## Aquatic Center Committee

**SUBJECT: WATER SLIDE STRUCTURAL EVALUATION**

**PROJECT: WHITEWATER AQUATIC AND FITNESS CENTER  
WHITEWATER, WISCONSIN  
RAMAKER AND ASSOCIATES PROJECT #64588**

## WHITEWATER AQUATIC FITNESS CENTER FACILITY LAYOUT

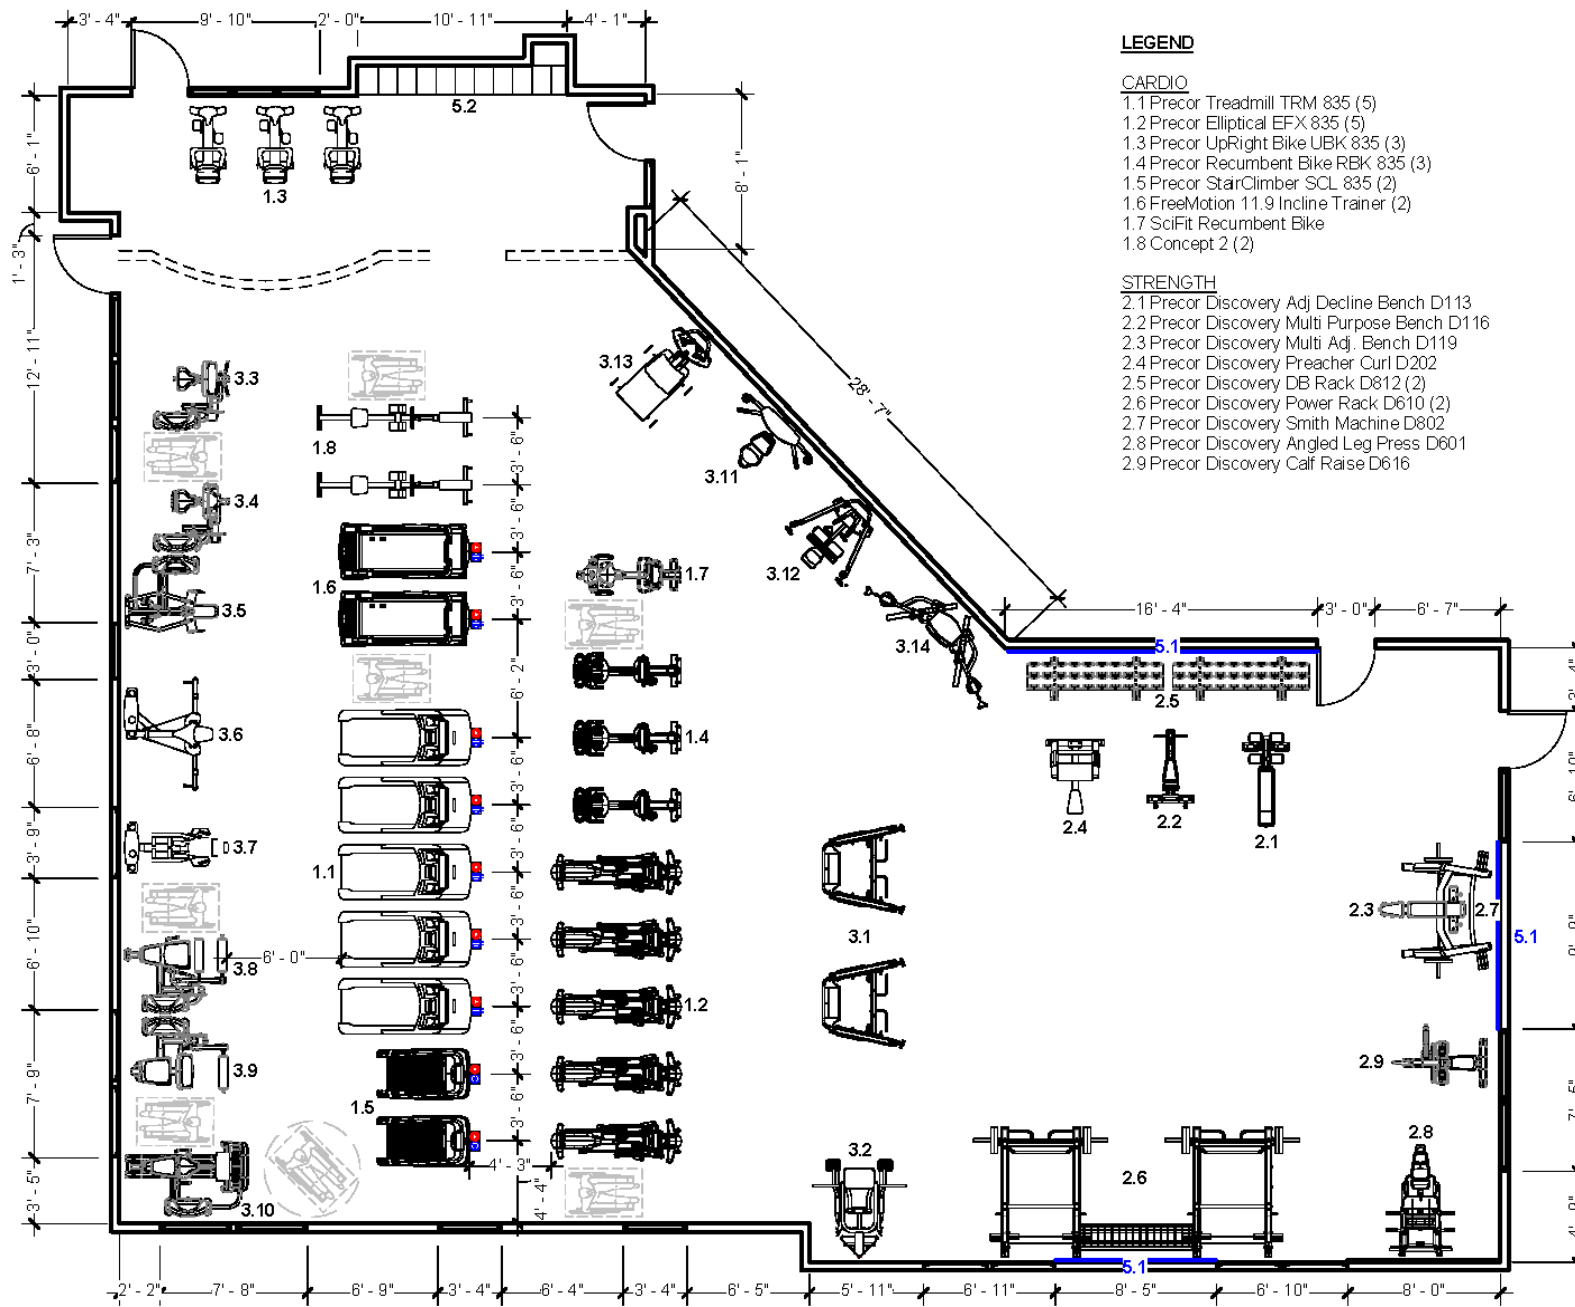
Manufacturer Recommendation:  
Strength equipment systems taller than  
4' should be secured to the floor via  
securing brackets.
